# P802.1CM – D0.3 Editor's Report

May 26, 2016

Figure 5-0, Functional Parts of a Cellular Base Station

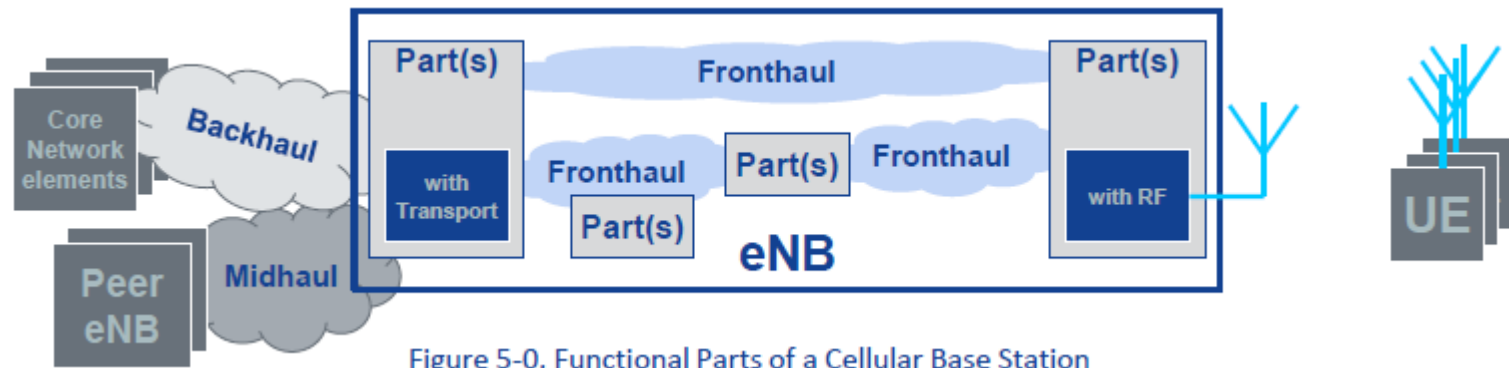
- › A figure illustrating midhaul and backhaul has been proposed to be added

- “Fronthaul link can also be connection between two DUs.” This is rather midhaul.
- › Editor’s concerns
  - Only fronthaul is in scope of 802.1CM, midhaul and backhaul are not
  - We should not introduce terms that are not in scope

Figure 5-0, Functional Parts of a Cellular Base Station

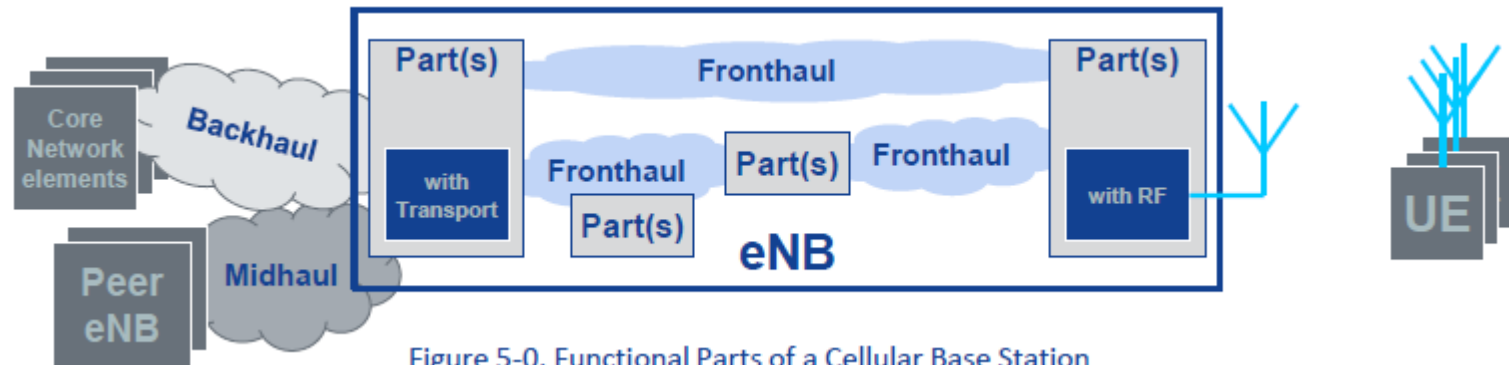
- › A figure illustrating multiple fronthaul network domains has been proposed to be added

- › Editor's concerns

- The scope of 802.1CM is single domain
- 802.1CM specifies how to provide fronthaul by a bridged network
- Part(s) of the above figure are End Stations; it is out of scope for 802.1 to specify how an End Station interconnects bridged networks
- A network operator may use multiple fronthaul bridged network domains as components and build a set-up shown in the figure or different ones
- 802.1CM should not specify multi-domain or how individual fronthaul network domains are used as components
